**Sent:** 31/08/2020 3:00:42 PM  
**Subject:** DA 2020/0816 23-33 BASSET STREET MONA VALE - Submission/Objection  
**Attachments:** bur.bas37m4\_submission\_TGNNPLB\_310820 (8).pdf;

**DEVELOPMENT APPLICATION DA 2020/0816  
23-33 BASSETT STREET MONA VALE  
PROPOSED RESIDENTIAL CARE FACILITY UNDER SEPP HOUSING  
FOR SENIORS**

This document is a submission by way of objection to Development Application 2020/0816 (the 'development application') relation to Nos 23 - 33 Basset Street Mona Vale (the 'subject property').

**Figure 1-** North elevation showing west boundary of site and relationship with adjoining cottage style development

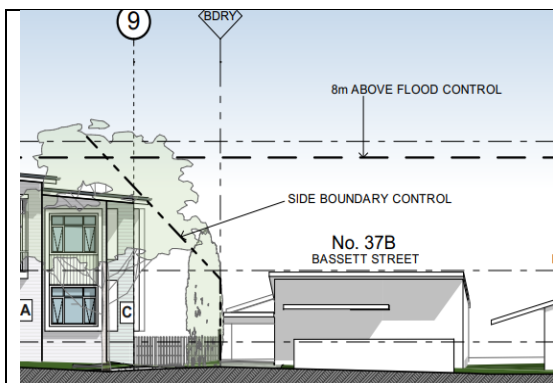
In our view the development fails to integrate itself properly into the objects of the desired future character for Mona Vale, as stated above. The above statement reflects the objectives sought to be achieved for that part of the Mona Vale Locality contained within the R2 Low Density zone under the PLEP.

This site is not in a medium density residential zone nor is the property located in a mixed use commercial type environment. The fact that the site is zoned for 'low density residential' purposes should be instructive to the applicant as far as the development proposal is concerned. This is especially the case where low density residential extant development is to be replaced by a high density facility (over the eastern part of the land). We contend that the architect has failed to take into account the reasonable expectations of adjoining land owners and occupiers in this regard. Figures 1 and 2 below show the relationship between the proposal and adjoining development to the east and west (source Gartner Trovato Architects). In our opinion the separation between the built elements in Figure 1 is not acceptable.

**Figure 2-** North elevation showing east boundary of site and relationship with adjoining cottage style development

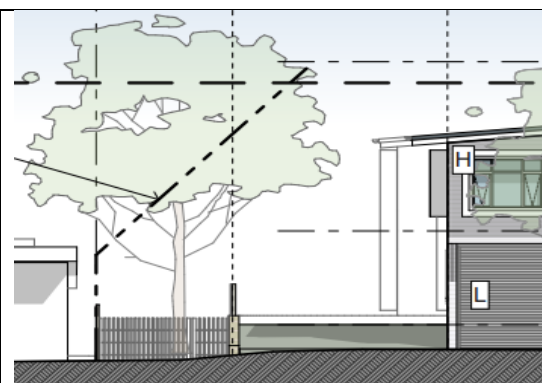
Below is an extract from the drawings by Gartner Trovato Architects, showing the length of proposed building (around 95m total), when viewed from Bassett Street. The long, unarticulated length of this facade, is completely uncharacteristic of adjoining and nearby development. As Council will be aware the existing building is at odds with the nearby building character. When this bulk is extended for a further distance along Bassett Street, a significant change in the dominant character of the southern side of Bassett Street will result. In our minds this is particularly undesirable.

In our view the building should be broken into at least two built elements crossways, so that some respect can be paid to the built form of existing cottages in other parts of this streetscape (with their narrow frontages), the relevant low density zone and the PDCP character statement suggesting that vegetation should be integrated with development. In this case the reduced street setbacks will not allow for sufficient planting to soften this bulky and very lengthy facade.
